Foothills Water Network River Reach Access Proposal 9/19/2015

Our House Dam

Figure 4, Potential Trail location below New Colgate Powerhouse.

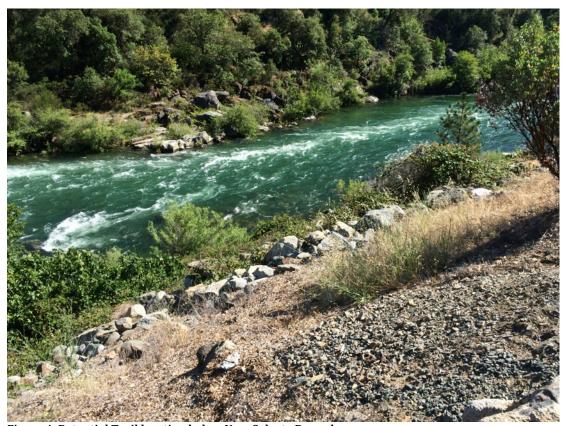
Currently, there exists a pathway (catwalk) around the powerhouse to give anglers access to the North Fork Yuba River above the powerhouse. Unfortunately, the configuration of this catwalk makes it extremely difficult for paddlers to carry their boats around the powerhouse. We recommend that the licensee construct a trail from the roadway, downstream of the new Colgate powerhouse, to the river's edge. There is parking for at least 10 to 20 cars at this location. A restroom needs to be provided to serve all of the recreation that occurs at this location.
